From: Dave White [david@civicworks.ca]
Sent: Thursday, June 01, 2017 9:40 AM
To: City Clerk
Cc: George Trutina; Peter Trutina
Subject: RE: BYLAW28P2017 Public Hearing June 12th, Springbank Hill ASP, Landowner (Truman) Input to Council
Attachments: 17.03.29 ASP Amendment Draft Review Letter - Truman Lands.pdf

From: David White <david@civicworks.ca>
Date: Wednesday, April 19, 2017 at 5:54 PM
To: "cpc@calgary.ca" <cpc@calgary.ca>
Cc: George Trutina <george.trutina@trumandevlopment.com>, Peter Trutina <peter.trutina@trumandevlopment.com>, Alex Baum <abaum@cochranetoyota.com>, Wayne Heth <waheth@shaw.ca>
Subject: Truman/Landowner Comments, CPC 5.05 - Springbank Hill ASP

Re: Major landowner (1919, 2025, 2229, 2331 - 77 ST SW, 19.1 ac. +/-) concerns regarding revisions to the proposed amendments to the Springbank Hill Area Structure Plan between 31 January 2017 and 16 March 2017

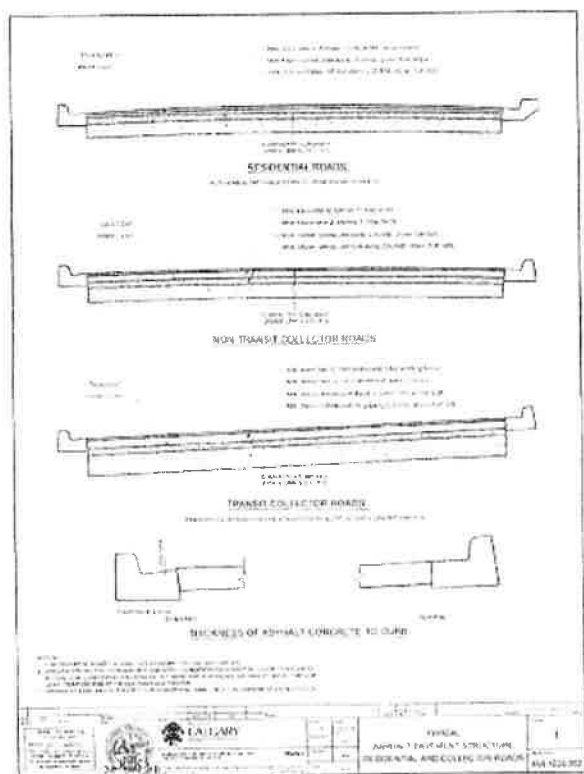
R.O.W. The original R.O.W. of 81st Street was 66 feet (20.1168 metres). Of that 2.56 metres on the east side was closed in 2008 (LOC 2008-0101 see drawing below), the road was built at 9 metres with a 3 metre R.O.W. on the east side. That left what was then referred to as an "interim R.O.W." of only 17.56 metres, of which 2.56 metres on my side (west) was identified as a "future road closure" leaving an ultimate 15 metre R.O.W., which is standard for a "Residential" road. I was told by city staff that I would have the option to purchase the "future road closure" when I developed my land.

Therefore, the current R.O.W. is insufficient for even a "Standard Collector" road let alone a "Primary" one. You state that the road closure of 2008 "will have no real effect on equality of subdivision conditions for you in the future" but to create anything other than the residential road it has been built as would.

Perhaps now you can appreciate my concerns and objection to having this portion of 81st Street re-designated from a "Residential" to a "Collector" road and also a "Proposed Transit Route" in the new ASP.

The Complete Street Policy allows for modifications of these street types to accommodate variations within the right-of-way (pavement or right-of-way width, number of lanes, street furniture/lighting, sidewalks, bike lanes etc) and even right-of-way dimension variations for situations of retrofitting streets that portions may be constructed and or right-of-way could already be established on one or both sides of the street (like 81 Street SW adjacent to your property). As there is sufficient pavement width (9 m) constructed along your property for 81 Street SW, there is sufficient width for cars and transit buses to operate consistently with a Collector street type. As such, reconstruction of the pavement width adjacent to your property would not be required to operate 81 Street SW as a Collector (and transit route)

a) within the future boulevard to accommodate the needs of pedestrians, utilities, street lighting and street trees; where applicable and b) for pavement width to efficiently serve cars and transit buses for a Collector street. North of your property, 81 Street would transition in the future to more typical right-of-way widths as contained within the DGSS (2014). As such, Complete Streets and DGSS 2014 support operating 81 Street SW adjacent to your parcel as a Collector street with modified width and right-of-way.

- Will I incur any additional costs, over those I am already obligated for, because of the decision to re-designate this portion of 81st Street and transit to run buses on it? Subdivision conditions are determined at the time of subdivision. Exact costs are not known until that time. Operating 81 Street SW as a Collector and transit route would not change or increase the boundary street costs that would be borne by you at time of subdivision.
